# Hay Creek Valley Subdivision Letter of Intent Preliminary Site Development Plan

PCD File # SP-23-01

January 20th, 2023

# V1\_Letter of Intent.pdf Markup Summary 2-28-2023

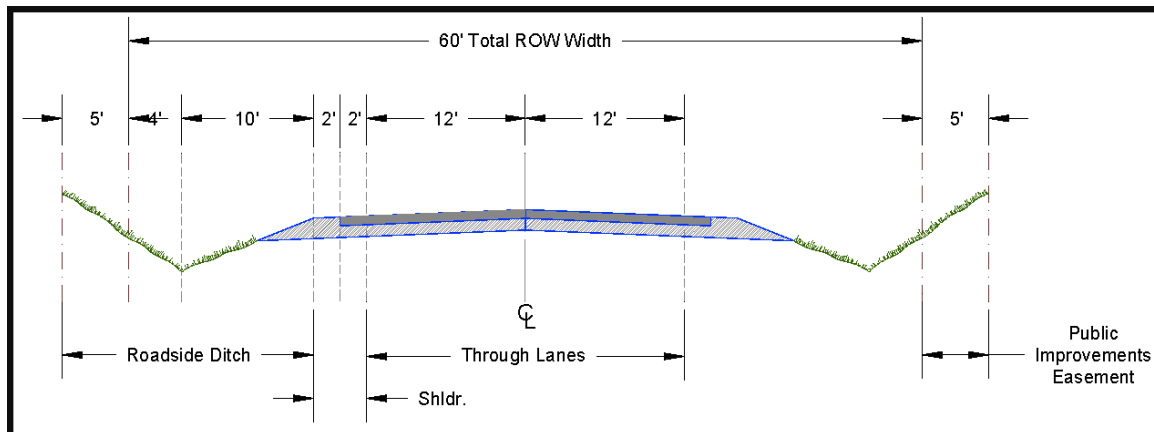
trips generated exceed ECM B.1.2.D. A Traffic Impact Study will be required. Please correct statement and submit TIS

to explain waiver request required for a private road. Provide discussion on what entity will own and maintain the road and the open space tracts to include Detention Pond. A BMP Maintenance Agreement will be required.

discuss discussion for deviation request for the length of the private road exceeding 1600ft per ECM Section 2.3.8. A formal Deviation request form must be submitted along with the TIS.
